Republic of the Philippines
BULACAN AGRICULTURAL STATE COLLEGE
Office of Bids and Awards Committee
Pinaod, San Ildefonso, Bulacan, Philippines 3010

Bid Bulletin No. 1
REPLY TO QUERIES AND CLARIFICATIONS BY BIDDERS

Name of Project:	2022-03-INFRA: Construction of Administration Building Extension
ABC: Php6,000,000.00

DETAILS OF WINDOWS GRILLS
SCALE 1:20

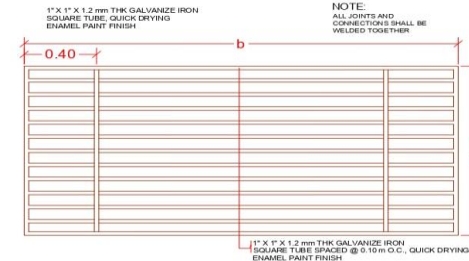
d. Details of Window Grilles.	See the drawing provided
	e. Total Area of Roofing Works	320 sq.m.
2.	Structural Works a. Please provide footing tie Beam schedule	we have no footing tie beams, only ground beams, FTB indicated in plans will replace by ground beam.

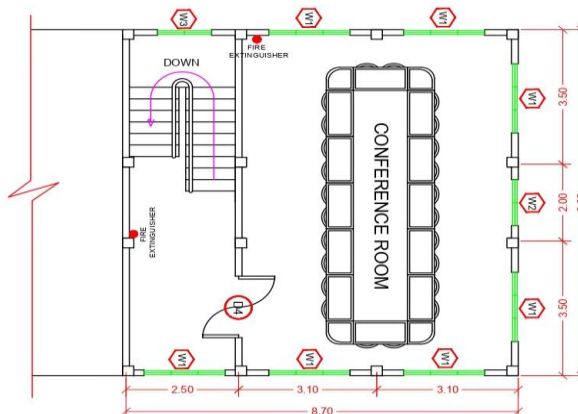
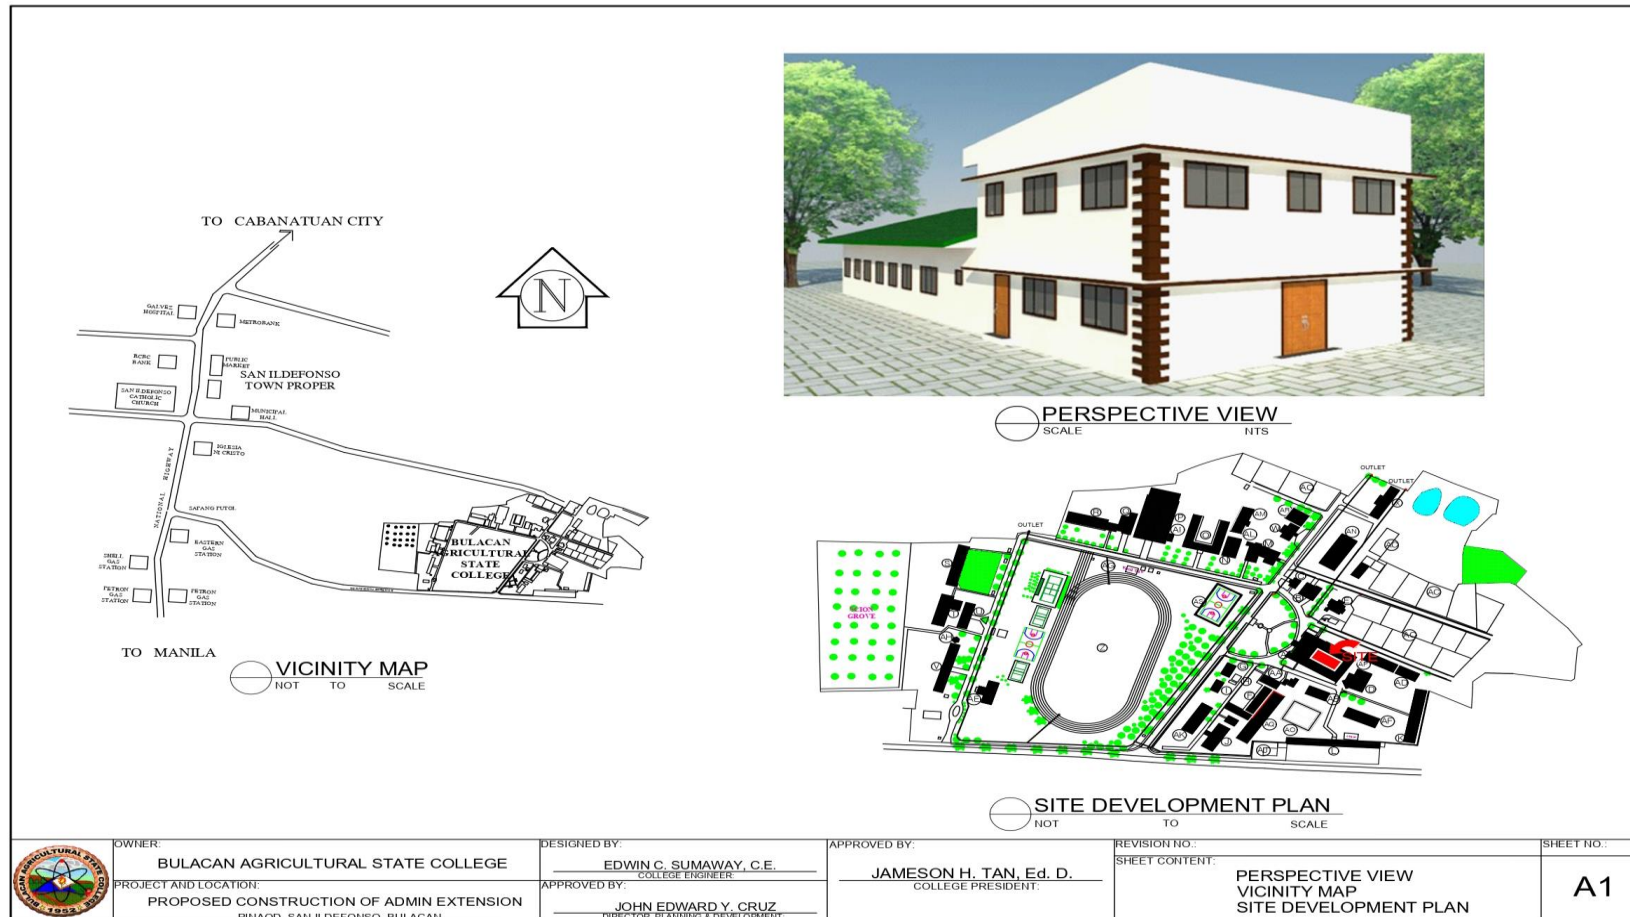
No.	Clarifications	Answer
1.	Architectural Works a. Discrepancy on Schedule of Door and Floor Plan (A2).	Lounge area is Door 1, instead of Door 2.
	b. Door jamb, is it Steel Door jamb or Solid Door Jamb?	Steel Door jamb
